ZEFFERT & ASSOCIATES**Accessibility Site Visit (Master)****CONTACT INFORMATION**

Project Name	Sample Property
Visit Type	1
Date of Inspection	01-15-2020
Inspector	Brian Jones
Site Visit Accompaniment	Kevin House/ Julio Perez
Next Action Required:	Physical Site Visit
City	Aiken
State	South Carolina
Number of Buildings	23
Total Number of Units	47
Number of HC Accessible Units	3
Number of A/V Units	1
General Project Notes:	<p>NOTE – Element Findings at Time of Inspection: This inspection report indicates individual elements as Yes, No, or N/A. Each element listed as Yes is compliant and requires no action. Each element listed as No is not compliant and requires action. Each element listed as N/A is non-applicable and requires no action or not installed at the time of inspection.</p>

Accessibility Site Visit Report - HC - ANSI

Project Name	Sample Property
Visit Type	3rd
Date of Inspection	02-12-2020
Inspector	Brian White
Site Visit Accompaniment	Jason Pendly
Street Address	123 Main St
City	Greenville
State	South Carolina
Zip Code	29605
Accessibility Codes for this project (Check if used)	2010 ADA, ANSI A117.1, UFAS
Number of Buildings	1
Total Number of Units	80
Number of HC Accessib

Cabinet hardware easily operated with one hand (ADA 309)	Yes
Refrigerator has 50% of freezer space below 54" max. AFF (ADA 8.4.6.6)	Yes
If required per NFPA fire alarm pull station permanently installed 48" max. AFF	
Common Kitchen Photos

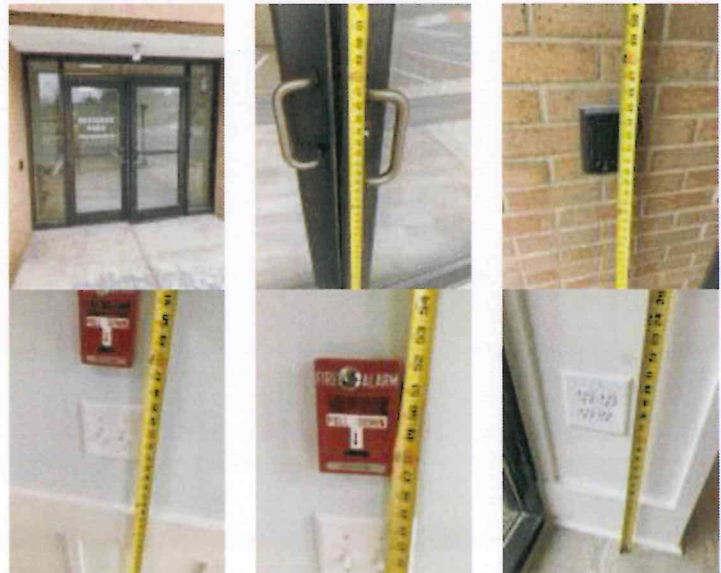
Status of this area	Finished stage
Doorway has a clear opening width 32" min. (ADA 404.2.3)	Yes
Threshold less than 1/2" with bevel or 1/4" no bevel (ADA 404.2.5)	Yes
Interior signs mounted (latch side) have tactile characters (measured from the baseline) between 48" min. - 60" max. (ADA 703.4.1)	Yes
Interior sign characters at least 5/8" but no more than 2" tall (ADA 703.5.5)	Yes
Electric switches/outlets 44" max. AFF over workspace others behind counter 46" max. AFF (ADA 308.2.2 (b))	Yes
Kitchen counters 34" max. AFF (ADA 804.3.2)	Yes
Top lip of kitchen sink 34" max. AFF (ADA 606.3)	Yes
Kitchen sink has 27" knee clearance, 30" clear width, and 9" min. height toe clearance (ADA 306)	Yes
Are drain and water supply pipes insulated or covered by skirt (ADA 606.5)	Yes
Faucet controls Lever Handle style or easy to operate (ADA 309.4)	Yes
Pass through kitchen has 40" min. clear width (ADA 804.2.1)	Yes
At least 50% of shelf space within 48" max - 15" min AFF (ADA 804.5)	No
